## Addendum 2 for RFB921500-01

Project Name: Grimes Lighting Replacement  
DAS RFB #: 921500-01  
DAS Project #: 9215.00  
Date: 09/15/2021

State of Iowa Capital Complex  
Grimes Office Building Lighting  
Addendum #2  
September 14, 2021

Drawing Name:  
**FIRST FLOOR HVAC  
PLAN**

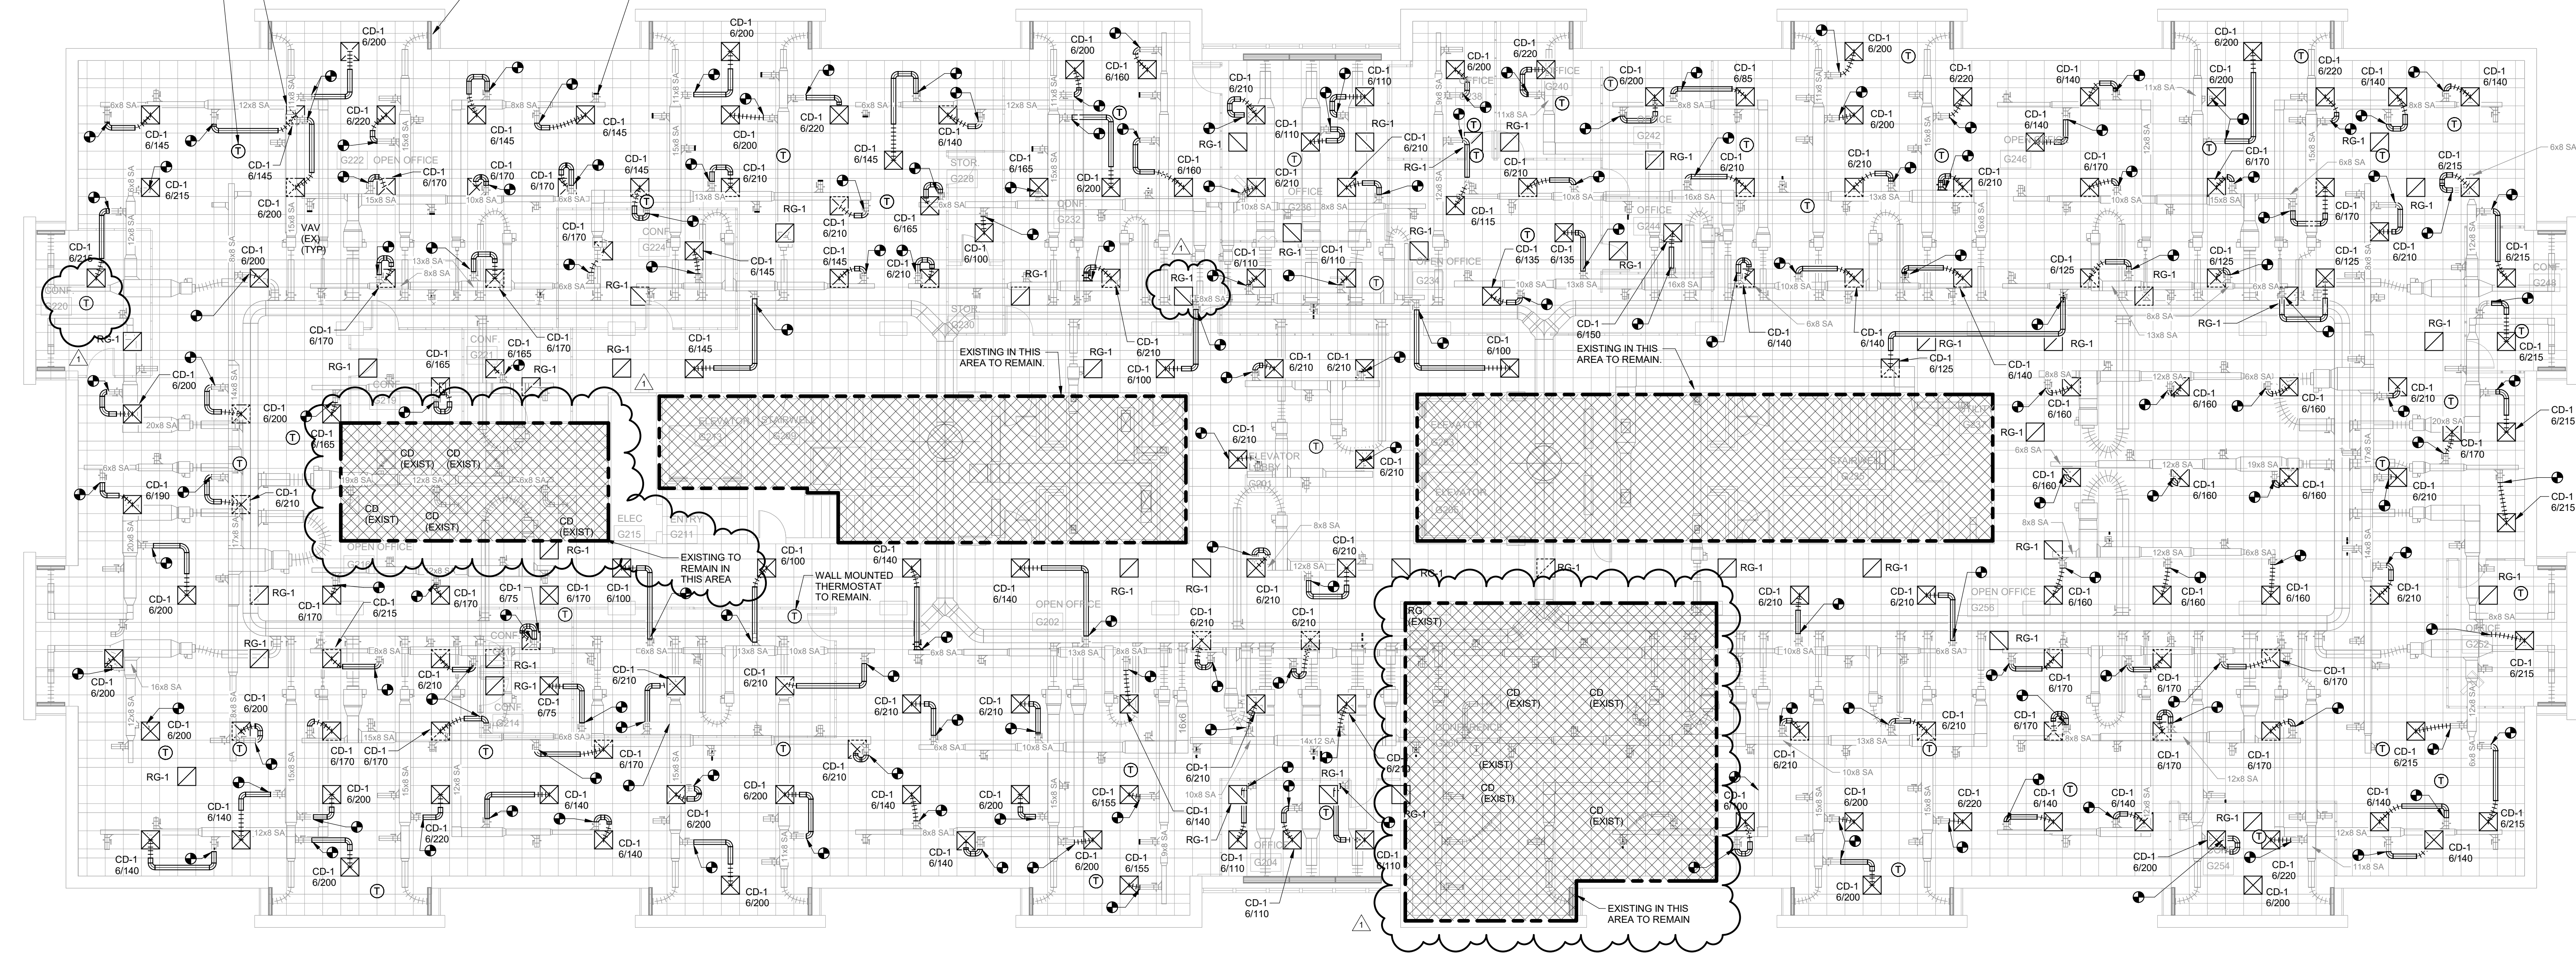
2. MD103 – Third Floor HVAC Demolition Plan
  - a. **ADD** the disconnecting/salvage of additional existing thermostats where indicated on revised sheet M103.
3. M101 – First Floor Plan HVAC Plan
  - a. **REVISE** drawing as indicated in attached revised drawing.
4. M102 – Second Floor Plan HVAC Plan
  - a. **REVISE** drawing as indicated in attached revised drawing.
5. M103 – Third Floor Plan HVAC Plan
  - a. **REVISE** drawing as indicated in attached revised drawing.
6. M300 – Mechanical Schedules and Details
  - a. **ADD** fire/smoke damper detail as indicated in attached revised drawing.

Drawing #:  
E101

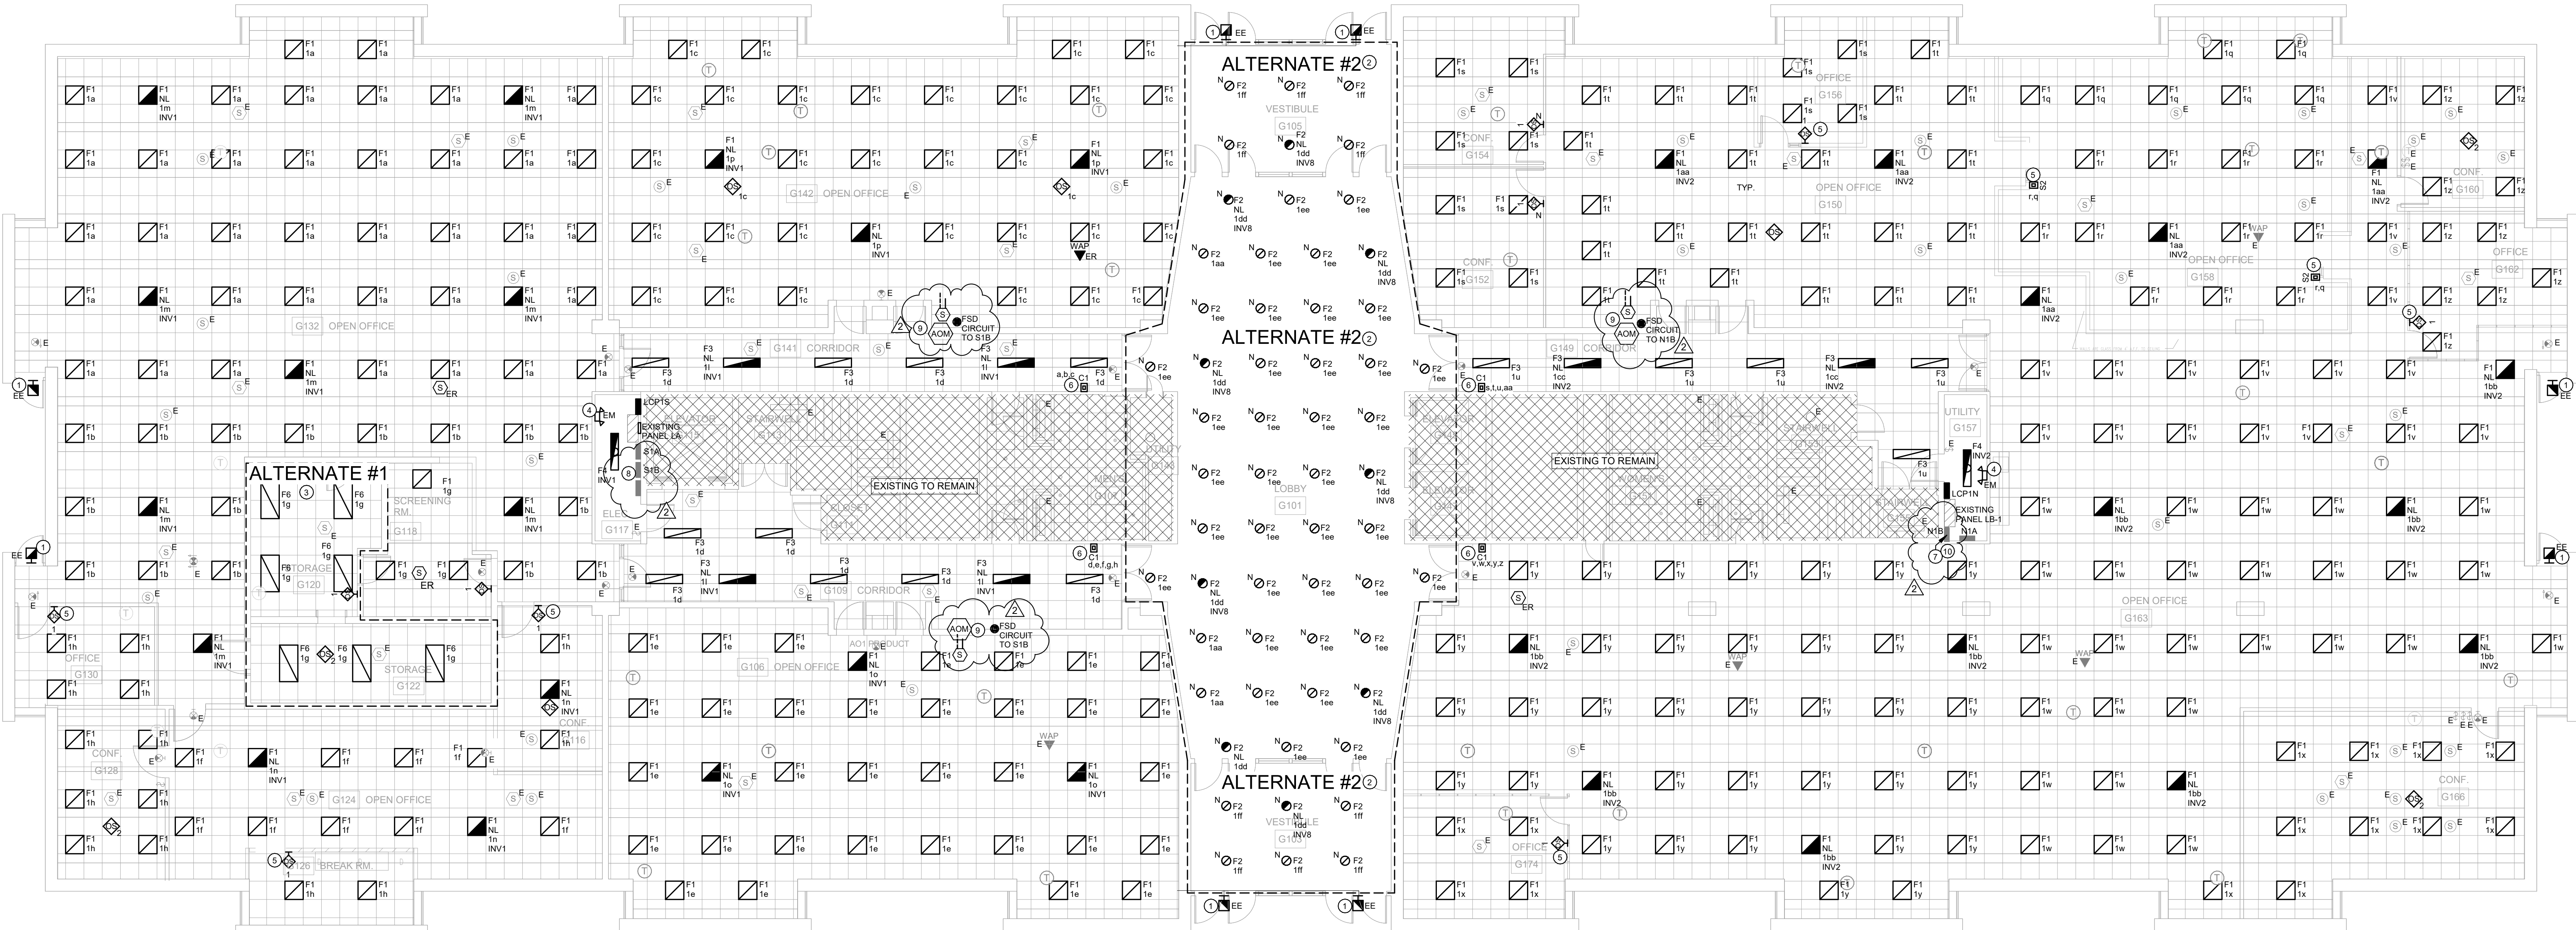
1. E101 - Electrical Lighting First Floor
  - a. **ADD** 120v 20A 1p Circuit in panel S1B and in N1B for smoke dampers.
  - b. **ADD** Duct smoke detectors in supply duct near dampers. Detectors shall close dampers upon smoke detection.
  - c. Refer to attached full size sheet E101.
2. E102 - Electrical Lighting Second Floor
  - a. **Revise** lighting controls in Conference room G219 and G221 to be three switch.
  - b. Refer to attached full size sheet E102.
